IMPORTANT SERVICE INFORMATION FOR: ✓ SERVICE MANAGER ✓ SERVICE ADVISOR ✓ TECHNICIAN ✓ PARTS DEPARTMENT ✓ WARRANTY PERSONNEL BULLETIN NUMBER: SB20-H-001

DTC P0027 AIR DRYER LINE REROUTING

2018-2019 MY Isuzu FTR vehicles Produced prior to January 2, 2019

Figure 13

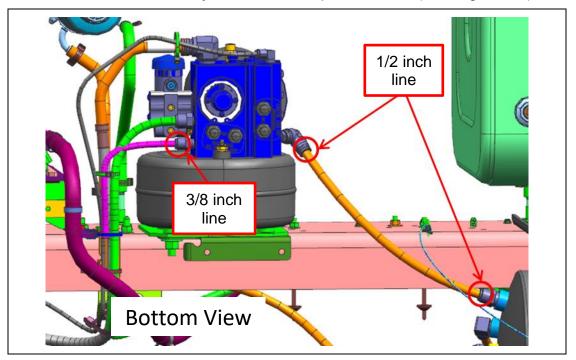
- 12. With a marker, draw a new insertion depth line ending 19.8 mm (25/32 inch) from cut end.
- 13. Insert the ½" line with cut end into swivel connector at port 23 AUX on the air dryer and other end into reservoir. (See Figure 13.)
- 14. Insert the 3/8" line into air dryer connector at port 22 SEC. (See Figure 13.)
